Subject: Software update for Cardiac Resynchronization Therapy Defibrillators (CRT-Ds) addresses the December 2017 Left Ventricular (LV) Offset Interaction. Reference: 92179817-FA

Summary Field Safety Notice (FSN)

Boston Scientific Software Update for CRT-Ds addresses Positive LV Offset Interaction

Appendix A – Identification of Programmer Software

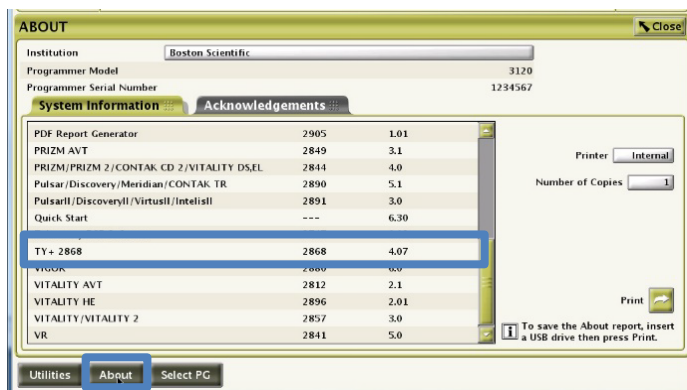
Confirm your Model 3120 ZOOM™ Programmer has received this software upgrade

Select About button and confirm Software Model and Version

Model 2868 v4.07

Supported CRT-Ds interrogated with this software are no longer at risk of permanent Safety Mode status due to a parameter interaction between positive LV Offset, A-Blank after V-Pace values, and Tracking Preference.
